**Report No. 49110-AR**

## **Investigation Report**

**Argentina: Santa Fe Road  
Infrastructure Project  
(Loan No. 7429-AR)**

**July 2, 2009**

**Figure 1. Watersheds of critical crossing points of RN 19's Section I.**

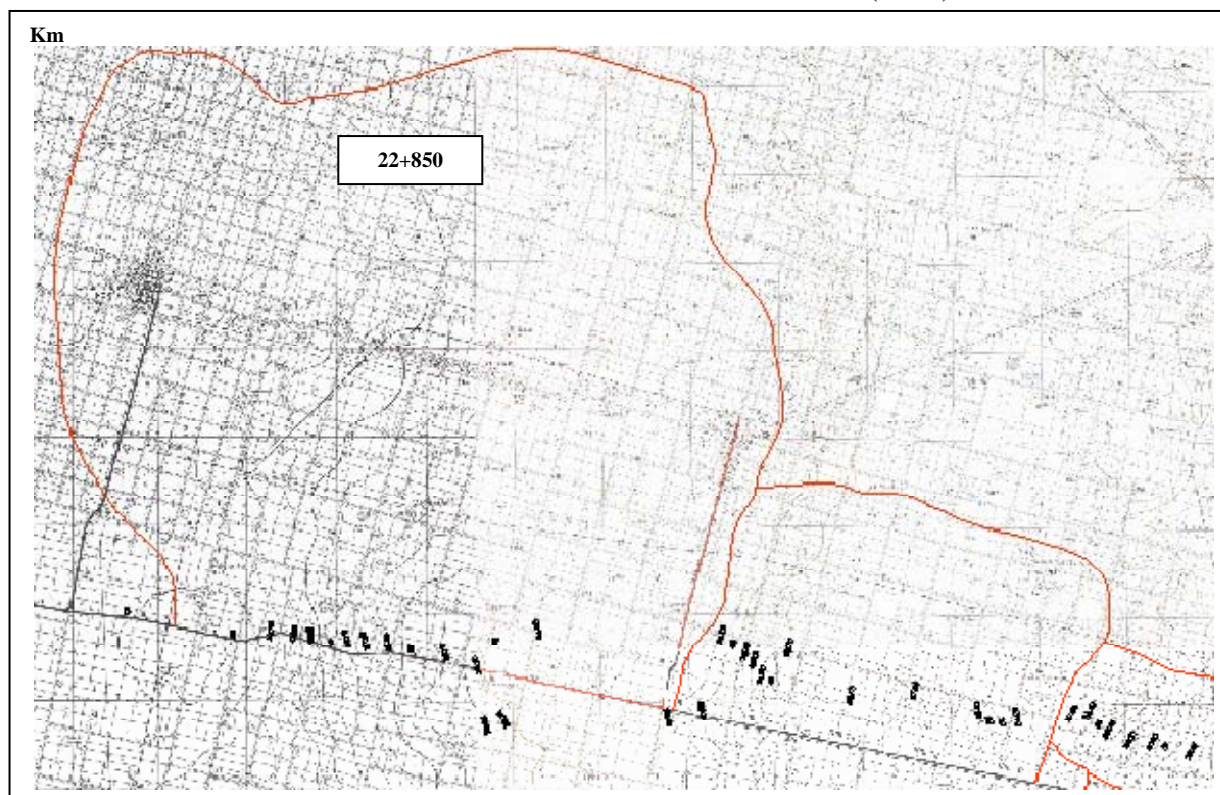
12. Figure 1 below shows the contributing watersheds to critical crossing points of Section I of the Road. Annexes 3, 4 and 5 attached to this Report provide information on the watersheds of sections I, II and III, respectively.

13. **The hydrological studies of sections II and III have explicitly taken into consideration land use changes and construction of informal channels built by the landowners to properly define watershed area and concentration time. This type of analysis was not conducted in Section I.**

**Figure 9. Hourly data of March 2007 storm -- Rafaela rain gage station**

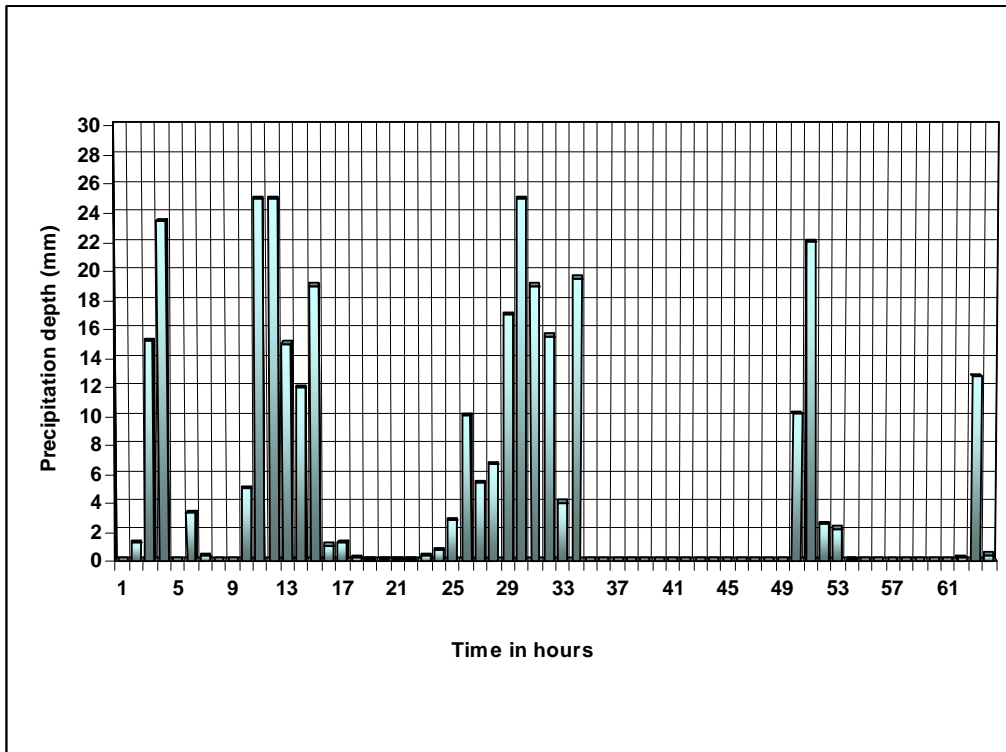
34. Analyzing Figure 9, it can be observed that the March 2007 storm event was produced by the joint occurrence of a sequence of storms; in other words, it was not an isolated storm but rather a cluster of several storms. This observation will be discussed in detail in the next section, as part of the discussion of selection criteria for rainfall-runoff models.

50. To understand the complexities inherent in the temporal variation of extreme rainfall events, it is suffice to observe the graph of hourly rainfall of the March 2007 extreme event shown in Figure 9, and then compare this graph with the assumption made in the hydrological study of Section I (Cornero, 2007), where the 50-year storm event is represented using just one value,  $R_{50}=80.5$  mm/hour.

**Figure 10 - Flood hydrographs for the C3 Watershed**

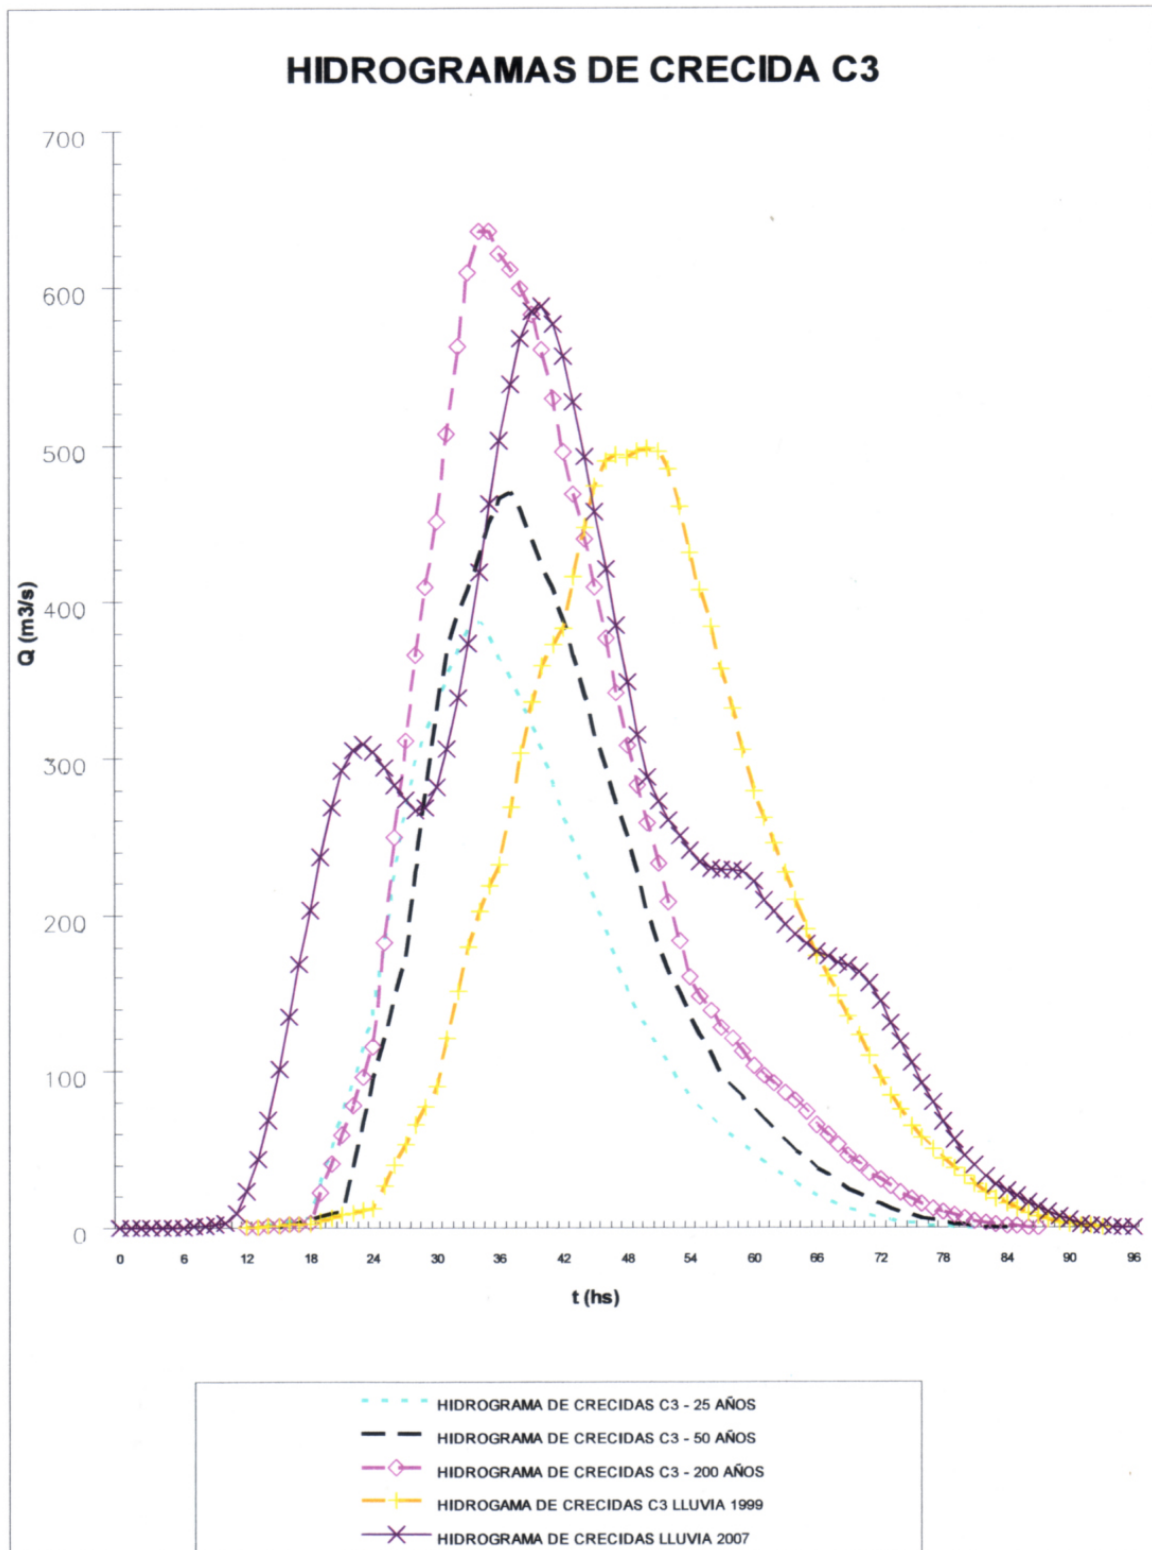
43. It is important to note that the effect of the magnitude of the peak flows generated in the "*Cañada del Sauce*", "*Arroyo del Sauce*" and "*Arroyo Colastiné*" (C1, C2 and C3) watersheds on the Project's cross drainage structures is described in these studies, concluding that the new Project could handle a peak flow of 1200 m<sup>3</sup>/s, and also an upper bound of 1600 m<sup>3</sup>/s. Additionally, the studies analyzed the flood hydrographs corresponding to the 25- and 50-year return periods, and the resulting hydrograph of the 1999 and 2007 extreme storms.
44. As an example, Figure 10 shows the flood hydrographs for the C3 watershed (Arroyo Colastiné), corresponding to the 25- and 50-year return periods and the resulting hydrograph of 1999 and 2007 extreme storms (page 38 of Consulbaires, 2008).

Figure 12- Culvert Performance Curve with Roadway Overtopping

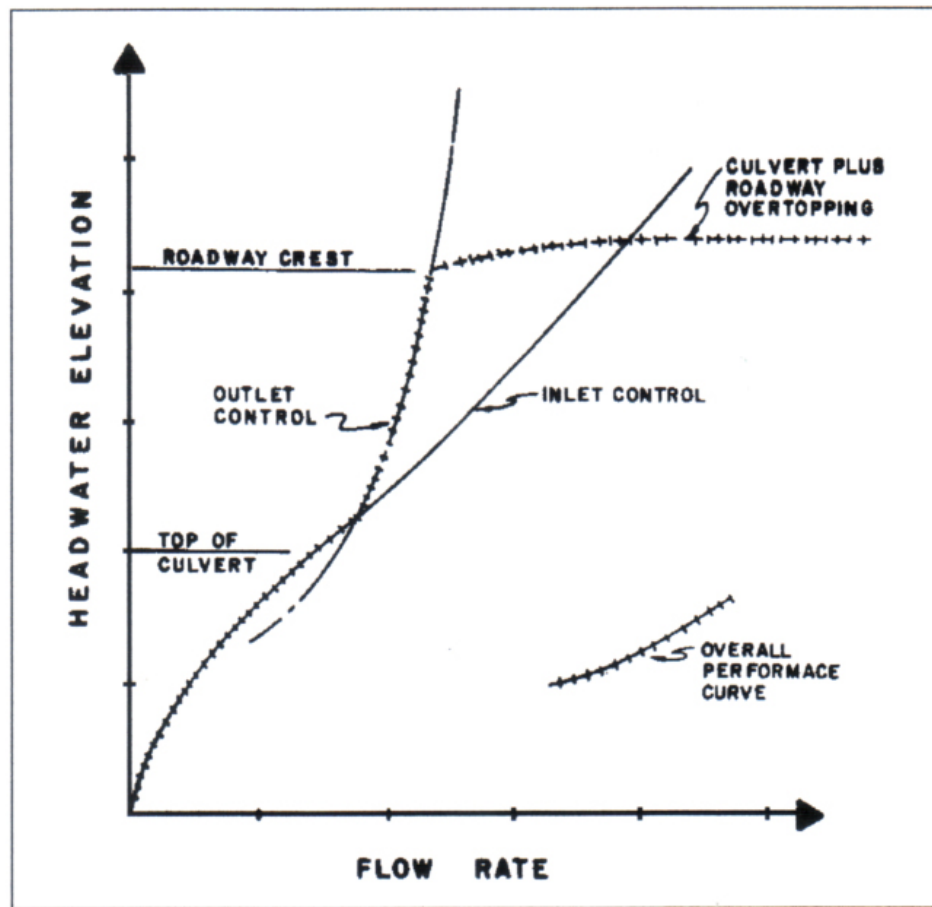
- Page 44: “Using the combined culvert performance curve, it is an easy matter to determine the headwater elevation for any flow rate, or to visualize the performance of the culvert installation over a range of flow rates.” Figure 12 depicts an example of an overall culvert performance curve with roadway overtopping. In this figure the change from inlet to outlet control can be observed.

- There is no determination of the flood hydrograph and, therefore, the flood wave is not routed through the potential temporary water storage that could be located upstream of NR 19 when the 50-year events occur.

- The hydraulic analysis is performed considering an isolated drainage structure.
- The analysis made an a priori assumption that the culverts will operate having upstream control (inlet control). The photograph in Figure 13 shows the culverts (two culverts of 5 meters width, 10 meters as a total width) which are being built at *Los Cuatro Sauces* East site (proposed road). Figure 14 shows the channel located downstream of the existing road (which in turn is located downstream of the proposed road) that has a width less than 2 meters at the bottom and less than 3 meters in the upper section. This situation implies that there is a high probability that the drainage structure hydraulic control will be located downstream, and that the structures will probably work with a submerged outlet. In this case, a downstream hydraulic analysis would have to be performed in order to determine the proper boundary condition (inlet control or outlet control).
